# Technical Service Bulletin

SUBJECT:		No: <b>TSB-18-42A-005</b>	
<b>TORQUE UPDATES: UNITS OF TIGHTENING TORQUE &amp; NUMERICAL VALUE FOR BODY - SERVICE MANUAL REVISION</b>		DATE: <b>December 2018</b>	
		MODEL: <b>2008-2014 Lancer Evolution</b>	
<b>CIRCULATE TO:</b>	<input type="checkbox"/> GENERAL MANAGER	<input checked="" type="checkbox"/> PARTS MANAGER	<input checked="" type="checkbox"/> TECHNICIAN
<input checked="" type="checkbox"/> SERVICE ADVISOR	<input checked="" type="checkbox"/> SERVICE MANAGER	<input checked="" type="checkbox"/> WARRANTY PROCESSOR	<input type="checkbox"/> SALES MANAGER

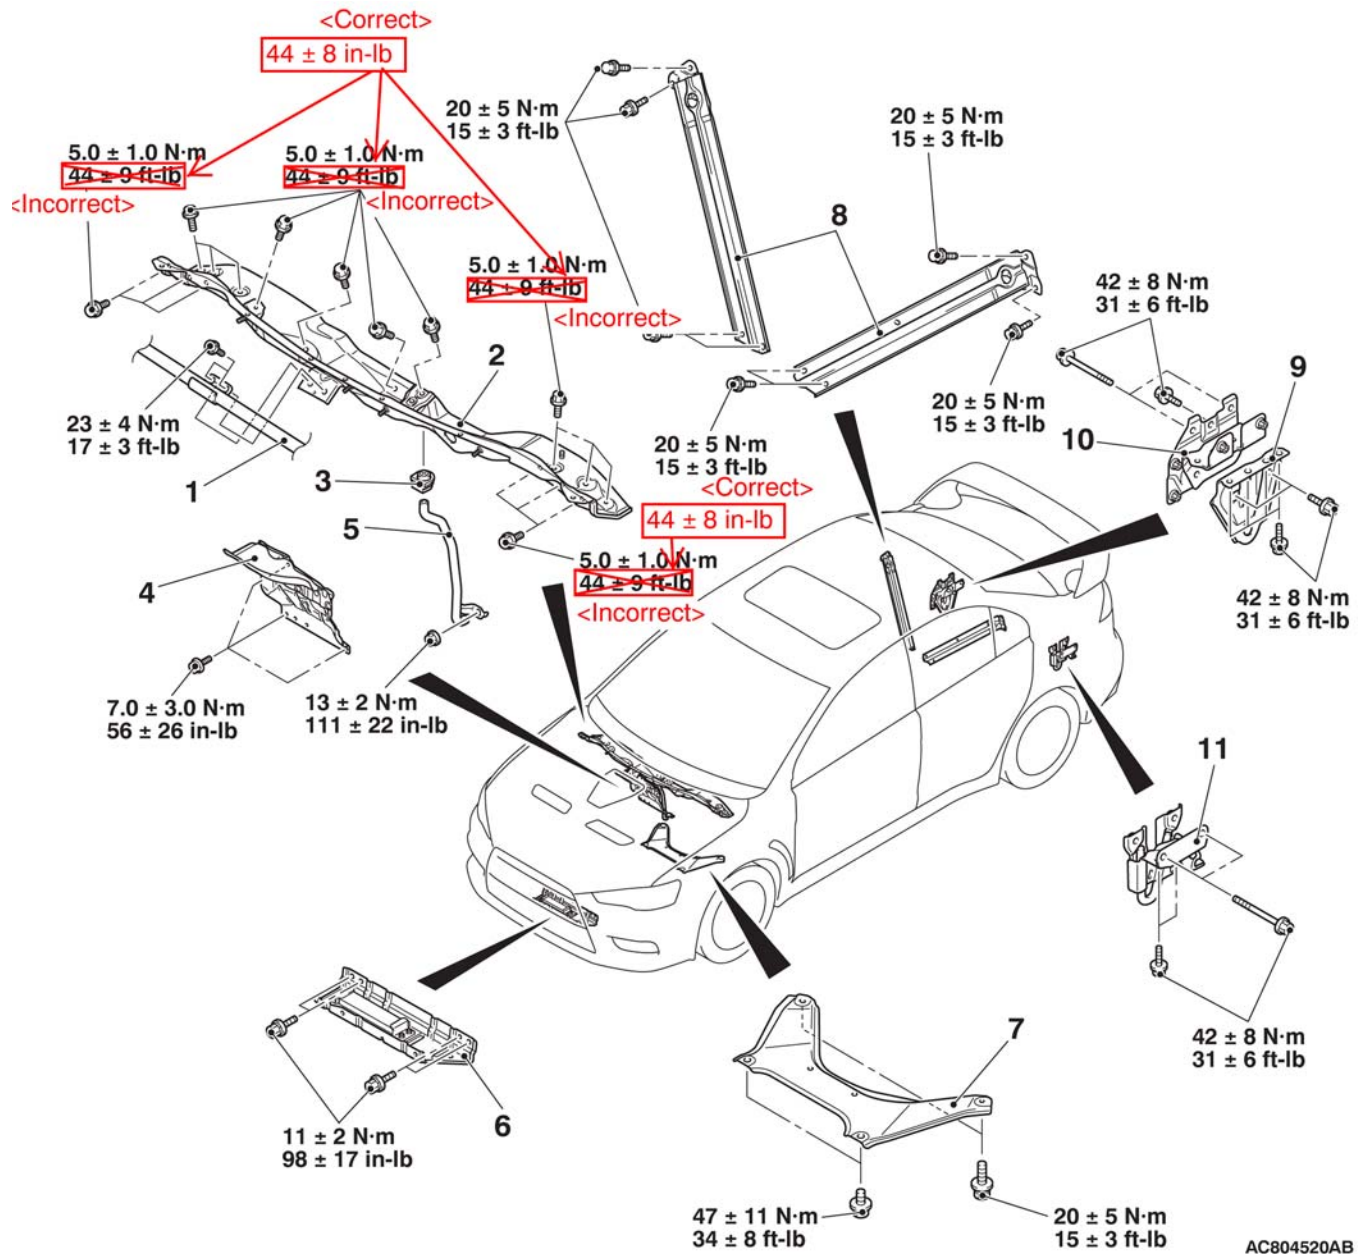
Please make the indicated changes to the 2008 Lancer Evolution Service Manual, Group 42 - Body -> Body -> Loose Panel.
